Bridle Trails Neighborhood Plan Update

Revised Plan - Strikethroughs and Underlines

Figure BT1: Bridle Trails Geologically Hazardous Areas

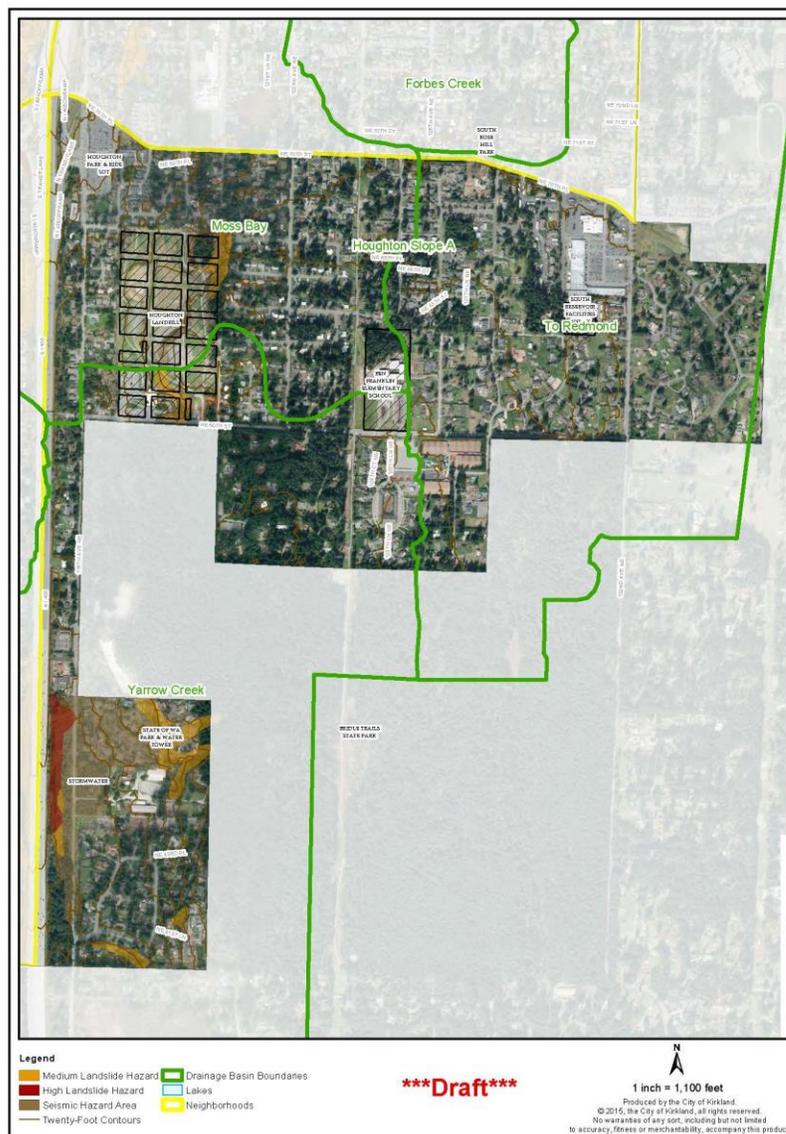
Landslide and seismic hazard Environmentally sensitive slopes areas are identified. Slope stability analysis should be required and development regulated accordingly.

Moderate and high landslide slopes and seismic hazardous soils exist An environmentally sensitive and potentially hazardous slope in the Bridle Trails Neighborhood occurs mostly on publicly owned land in the State Park and on the transfer station site between 116th Avenue NE and Bridle Trails State Park (see Figure BT-1). No severe problems appear to exist for many types of park development, although some areas of the transfer site may be subject to uneven settlement and contamination problems due to past landfill activities. Residential development is possible on this the slope area south between 116th Avenue NE and Bridle Trail of the State Park. A slope stability analysis should be required prior to any development on this slope. If landslide or drainage problems or excessive erosion are likely to occur as a result of proposed development, the type, design, and density of land use should be restricted as necessary to avoid the problems (see Natural Environment chapter).

Figure BT-3: Bridle Trails Land Use

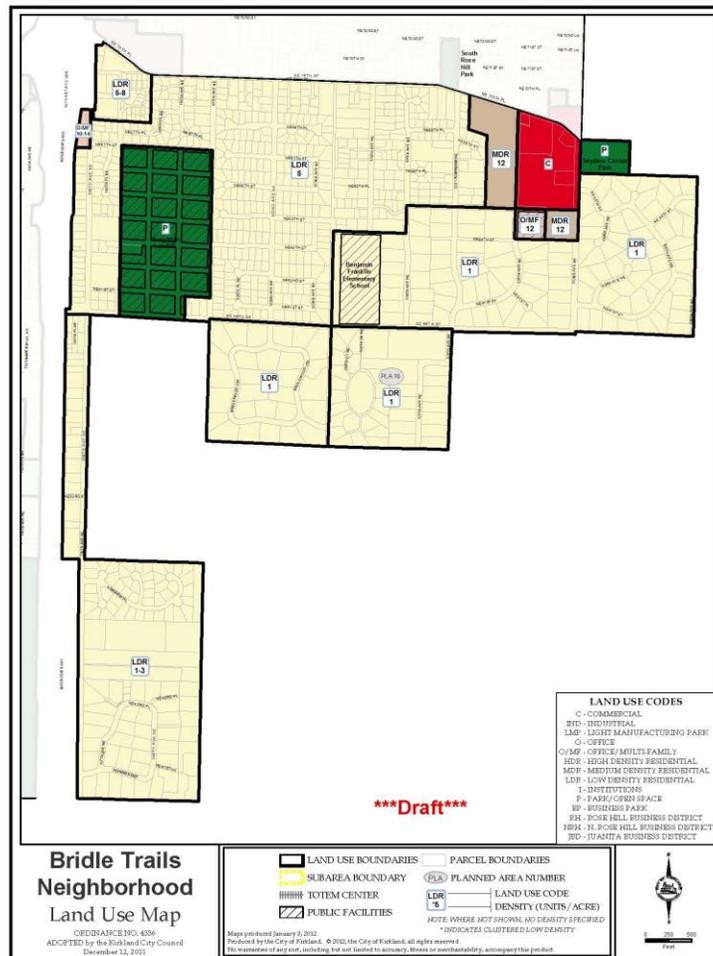
~~For the~~ The residential area developments east of I-405 are relatively new with the exception of a few older homes. ~~The~~ the major policy direction for this area is to maintain the low-density residential quality of the neighborhood, except as described below. New residential development should be low density (up to five dwelling units per acre) and conform with existing development based on Figure BT-3.

Figure BT-4: Bridle Trails Street Classifications

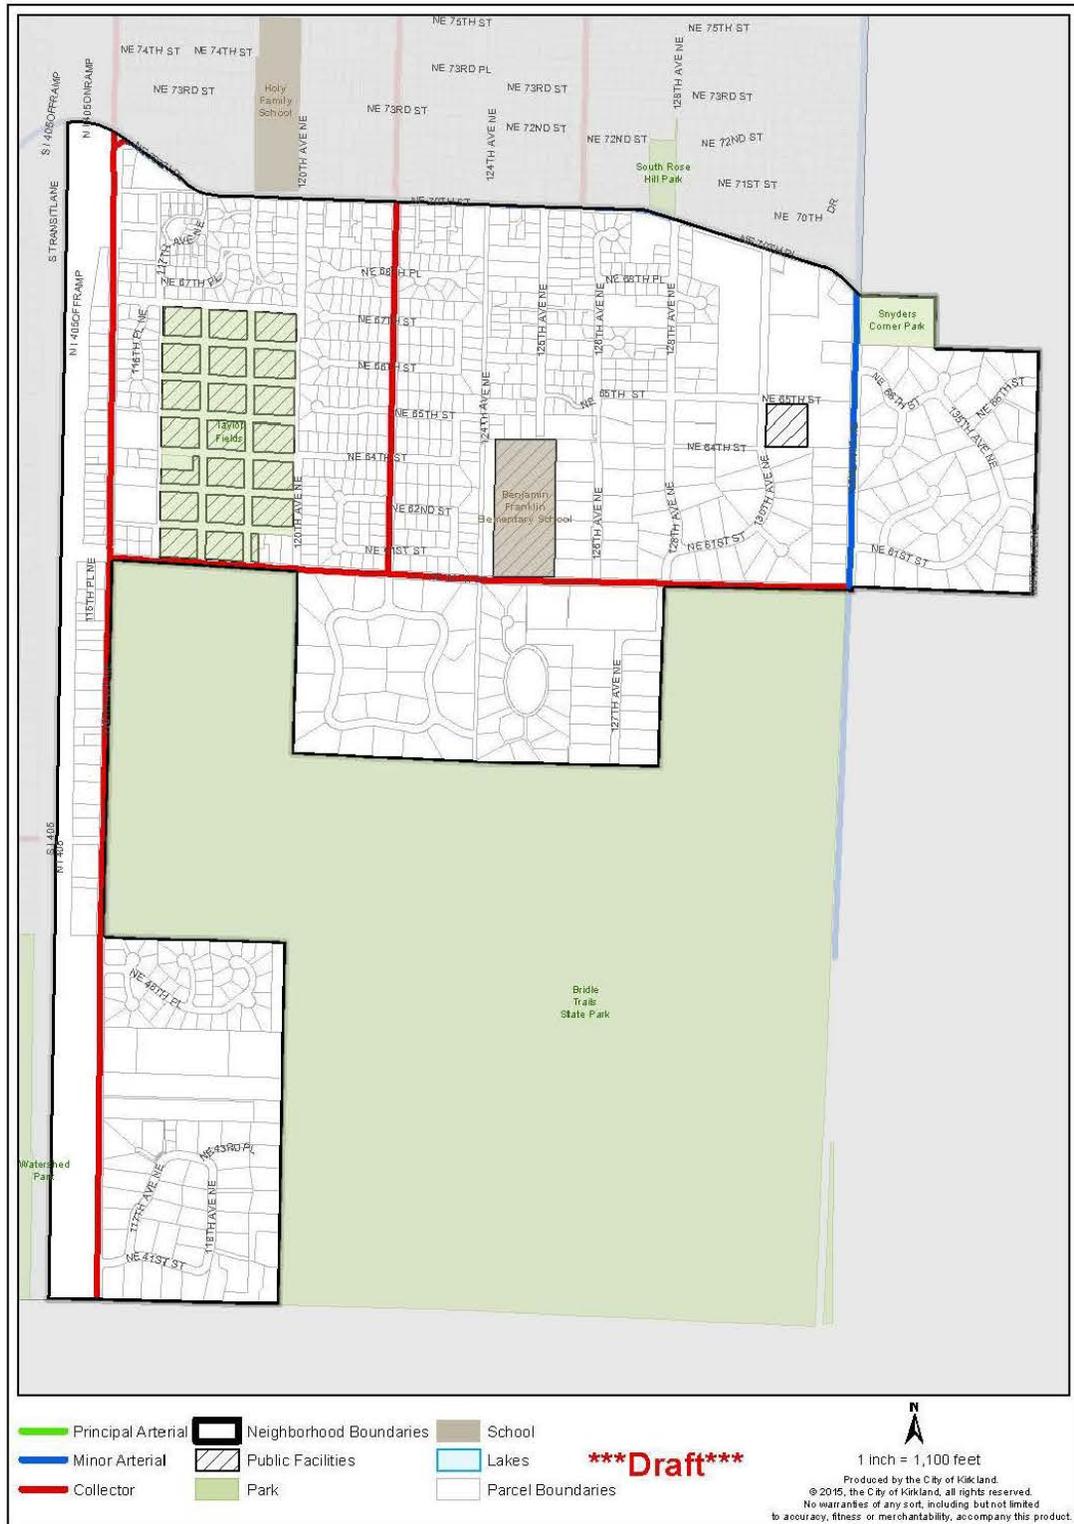
***~~Modifications to major roadways in the Bridle Trails area are listed~~
Pedestrian, bicycle and equestrian facilities should be made maintained and upgraded according to the Active Transportation Plan.***

Vehicular circulation patterns in the Bridle Trails Neighborhood are fairly well established. NE 70th Street is the primary east/west corridor for through traffic. Other arterials, 116th Avenue NE, NE 60th Street, 122nd Avenue NE, and 132nd Avenue NE facilitate access from most residential uses to the main arterials (see Figure BT-42).

***~~(1) NE 60th Street and 122nd Avenue~~
NE are collector arterials.***

~~NE 60th Street, 122nd Avenue NE, and 132nd Avenue NE should remain as collector arterials. No change in the road configuration should be necessary. However, there should be maintenance or improvements to pedestrian/bicycle/equestrian trails facilities should be made, especially on NE 60th Street, 116th Avenue NE and 132nd Avenue NE where provisions for a trail system separated from traffic should be included. Also, the removal of the transfer station would minimize reduce adverse impacts associated with trucks and vehicles utilizing this facility via the major roadways in the Bridle Trails area.~~

~~**(2) NE 70th Street should be designated as a secondary arterial.**~~

~~NE 70th Street should remain as a secondary arterial. This roadway provides through access from south Kirkland to Redmond. Future improvements to NE 70th ST this traffic corridor should include a three lane road, bicycle lanes, sidewalks, and provisions for the Metro bus system.~~

~~**(3) 116th Avenue NE should remain as a collector arterial.**~~

Figure BT:5 Bridle Trails Pedestrian System

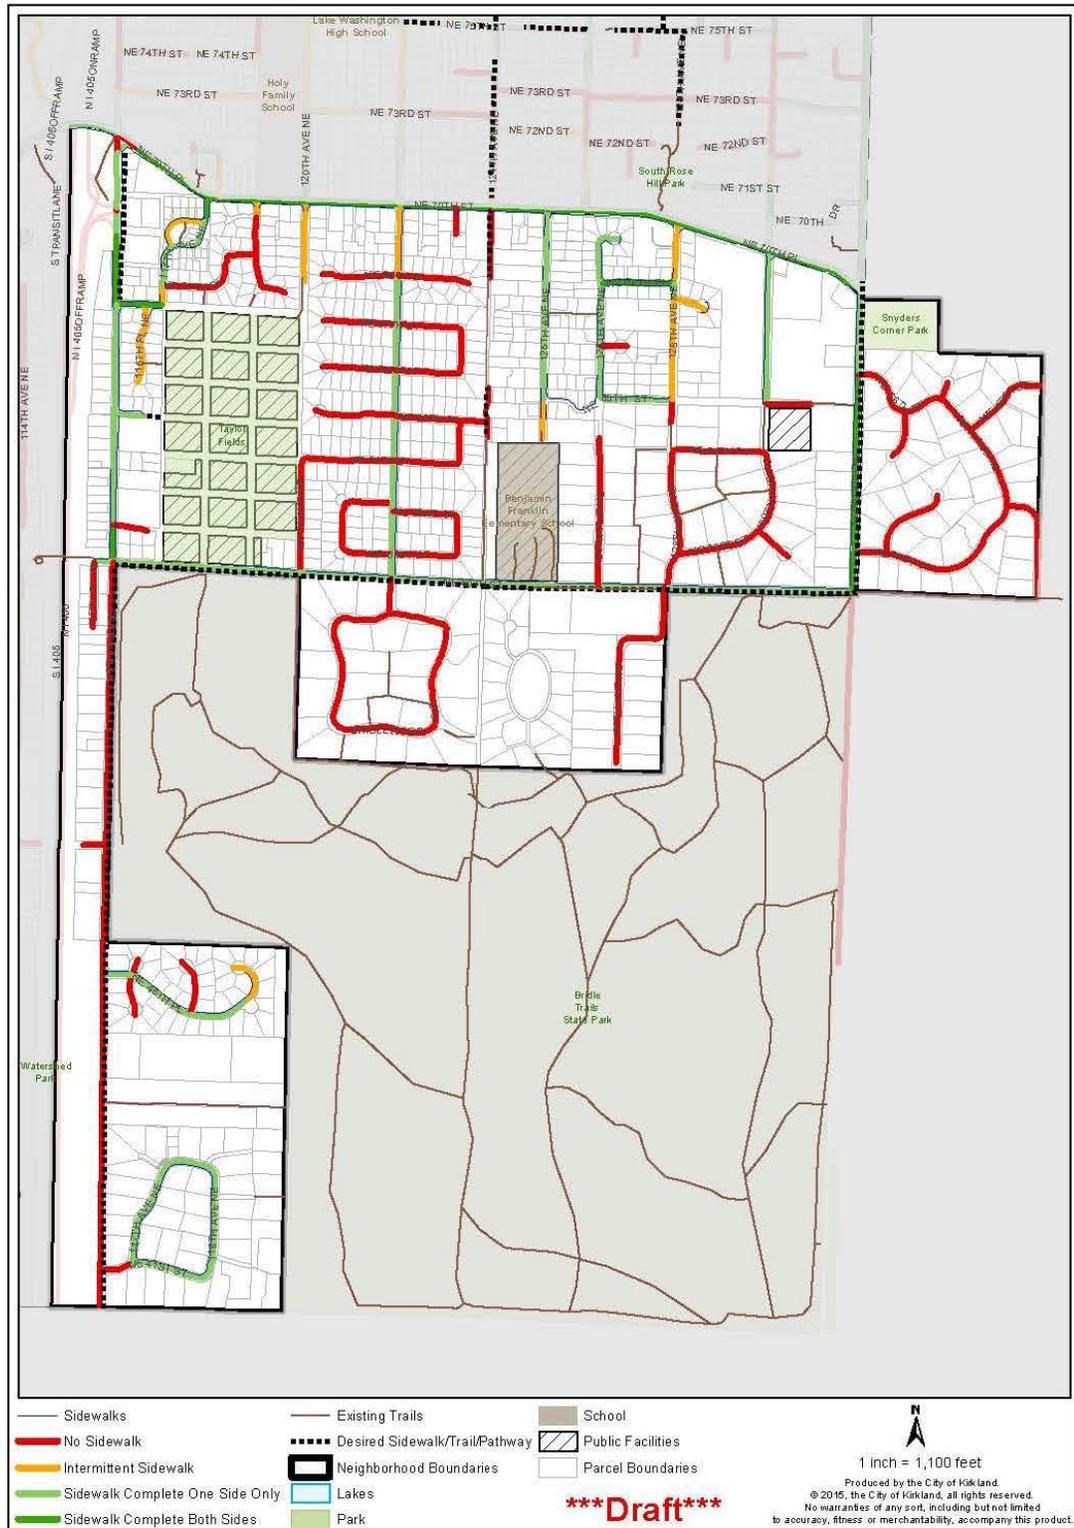
Pedestrian and bicycle pathways are also part of the park and open space system, in addition to providing a transportation function. Major pathways in the Bridle Trails Neighborhood should be established according to the designations in Figure BT-5 and 6 42.

~~Within the Bridle Trails Neighborhood, bicycle and pedestrian paths the path system are shown in the Transportation Element and Active Transportation Plan. Figure BT_5 does not include all existing and future sidewalks and paths but merely the major elements.~~

Figure BT-7: Bridle Trails – Urban Design Elements

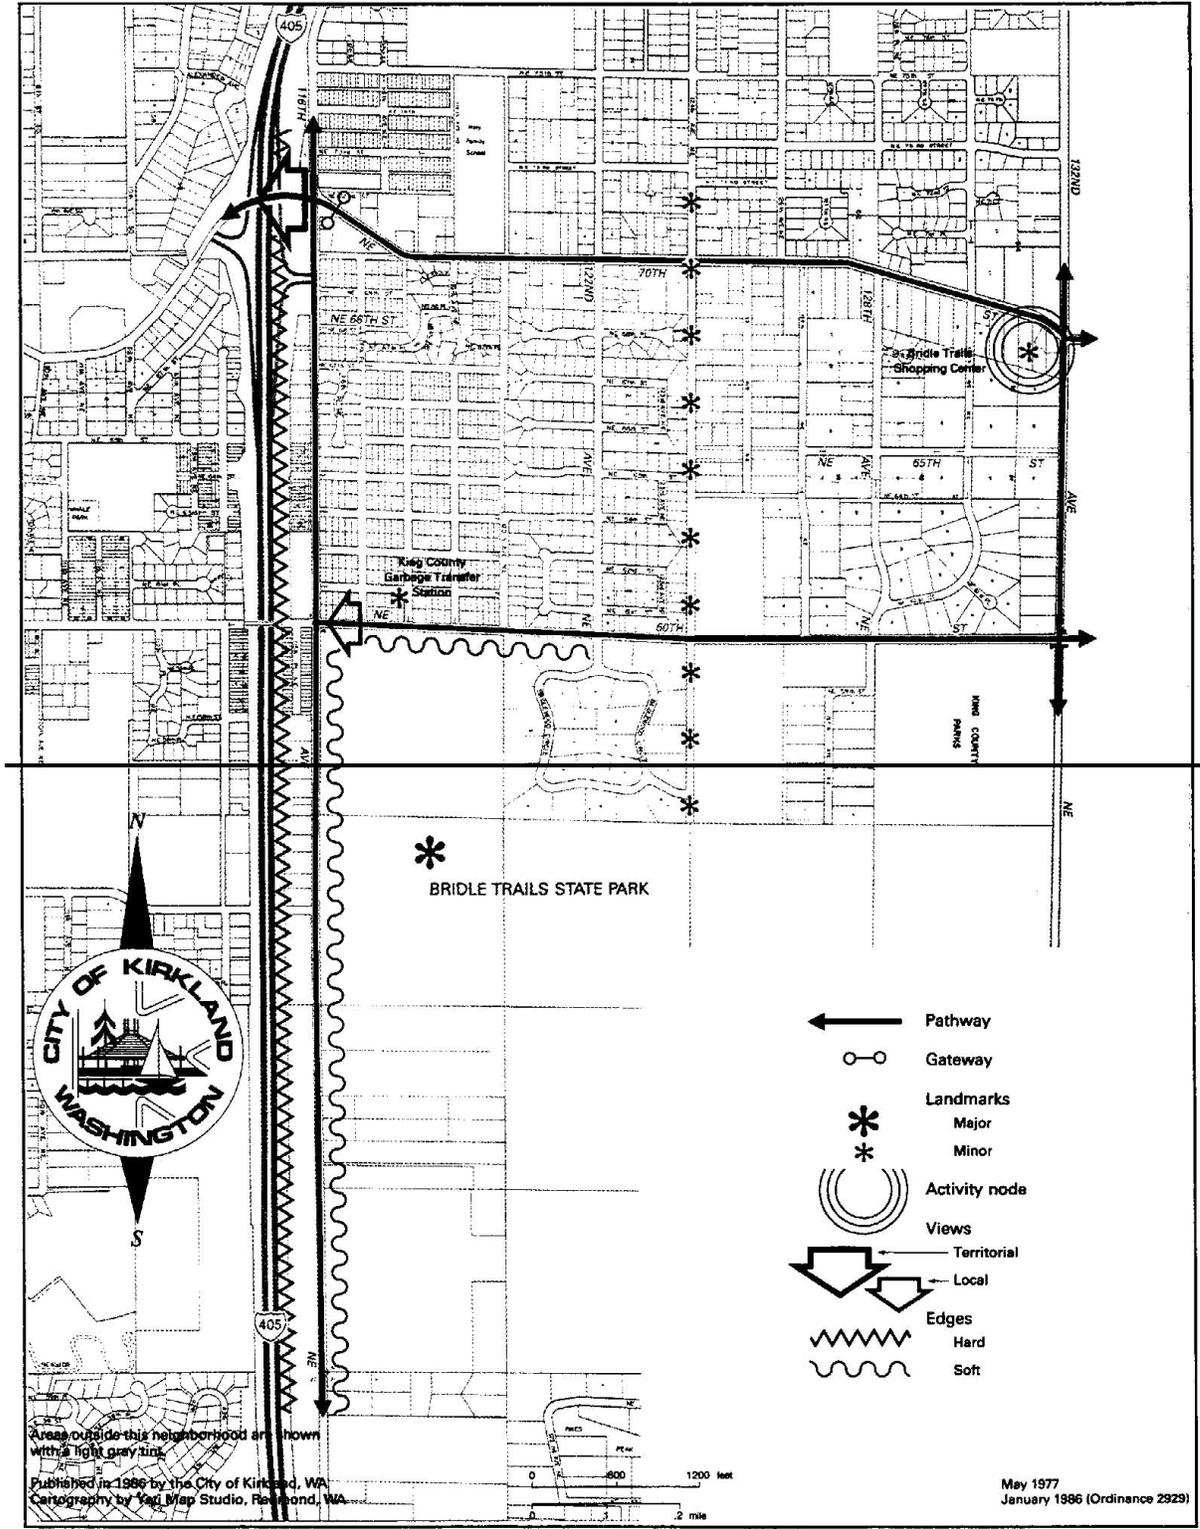
On the whole, the Bridle Trails Neighborhood has a clear and vivid visual image and identity. The neighborhood has a limited number of urban design assets, but they are very important in establishing neighborhood character (see Figure BT-7).

The neighborhood's western border is vividly and effectively provided by a ~~'hard edge'~~ Interstate 405. Major visual landmarks are the Bridle Trails State Park, the Bridle Trails ~~c~~Commercial Center, and the ~~high-voltage~~transmission power lines. The dominant visual landmark ~~is the~~ of the wooded State Park ~~creates a 'soft edge' which in turn reflects and reinforces the wooded and equestrian image of the neighborhood.~~ This image is quite apparent from the major 'pathways' through the neighborhood, NE 70th Street, NE 60th Street, 116th Avenue NE, and 132nd Avenue NE.

As an activity 'node,' the Bridle Trails commercial center is a focus of daily local commercial needs. The ~~high-voltage~~transmission power lines ~~and~~ 124th Avenue NE, an unopened right-of-way, run north and south dividing the neighborhood in half and are used as a point of reference.

A major view in this neighborhood is identified on Figure BT-~~73~~ -Urban Design. NE 70th Street and 116th Avenue NE present sweeping territorial views of Lake Washington, Seattle, and the Olympic Mountain range. The NE 70th view can be protected by limiting building heights of future structures directly west of I-405 in the northeast portion of Central Houghton and southeast portion of Everest Neighborhoods and by undergrounding utility lines.
